Subject: Additional Acoustic I-Audit for the Adelaide Wind Power Project
R754 - Phase 2
REA#8279-9AUP2B

This letter contains responses to MECP comments received on February 12, 2020 for the Adelaide Wind Power Project Phase 2 I-audit report for receptor R754 which are provided below. Original MECP comment is provided in black and Aercoustics’ response is provided in purple.

Figure 1 Measurement Dataset - R754 with Background wind direction filter

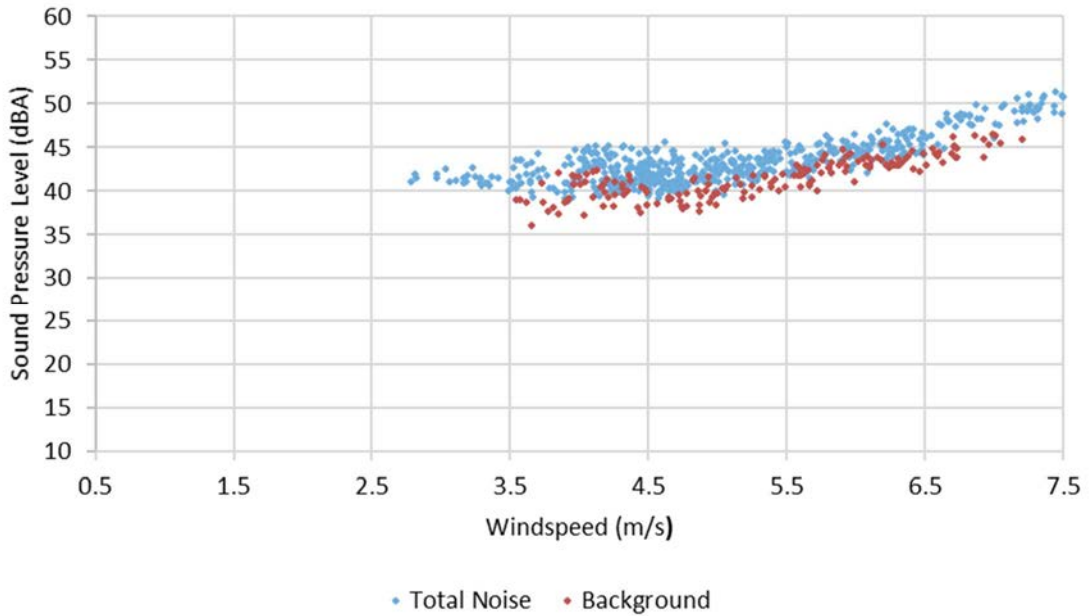
5 – Deviation from Protocol: The Turbine OFF data was filtered for downwind direction as stated in Section 3.3.3 of the audit report. Please comment on the impact that this will have on the background sound levels. Please conduct the sound level measurements without filtering the background data in the downwind direction, compare the results and demonstrate compliance without this additional filtering.

Removing the background wind direction filter in the Phase 2 I-Audit has the effect of including additional background data in the 1, 2, 3 and 4 m/s wind bins. There is no corresponding Turbine ON data in wind bins 1, 2 and 3 m/s. For the 4m/s wind bin two data points are added without the background wind direction filter and this additional data has a negligible effect on the average sound level for this wind bin.

As such removing the wind direction filter does not effect the analysis or conclusions of the report. Two tables presenting the average measured sound levels at the monitoring location with and without background wind direction filter and corresponding data visualizations of the assessment dataset is provided below.

Visualizations of the assessment datasets with a background wind direction filter is presented in Figure 1.
